5268/5294

**PARKING AND ACCESS/MANEUVERING SURFACE
VARIANCES TO ALLOW AGGREGATE PARKING AND
ACCESS/MANEUVERING AREAS IN A B-3, COMMUNITY
BUSINESS DISTRICT; PARKING AND
ACCESS/MANEUVERING AREAS MUST BE ASPHALT,
CONCRETE OR AN APPROVED ALTERNATIVE PAVING
SURFACES IN B-3, COMMUNITY BUSINESS DISTRICTS**

4213 HALLS MILL ROAD

BOARD OF ZONING ADJUSTMENT

SITE PLAN

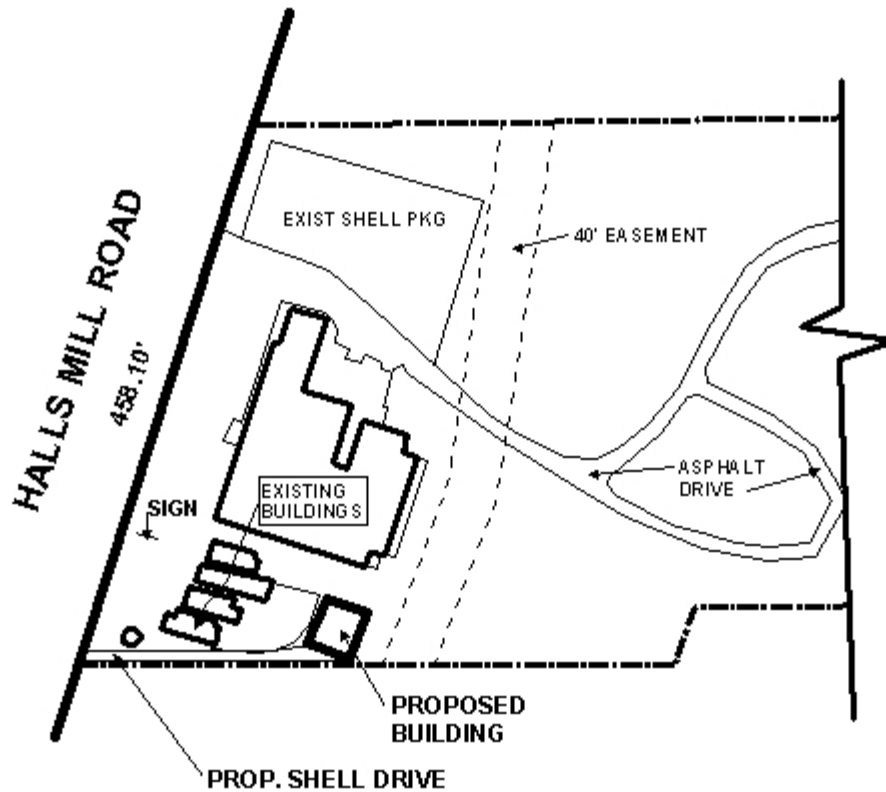
There are several reasons aggregate is not an approved surface, the probability of aggregate to shift onto the right-of-way and adjacent properties, access is not readily delineated, and without the appropriate compaction of the subsurface materials benefits toward impeding run-off will are not achieved.

The applicant failed to illustrate that a literal enforcement of the zoning Ordinance would result in an unnecessary hardship. It is simply the applicant's desire to construct an access/maneuvering area with substandard material.

Based upon the preceding, this application is recommended for denial.
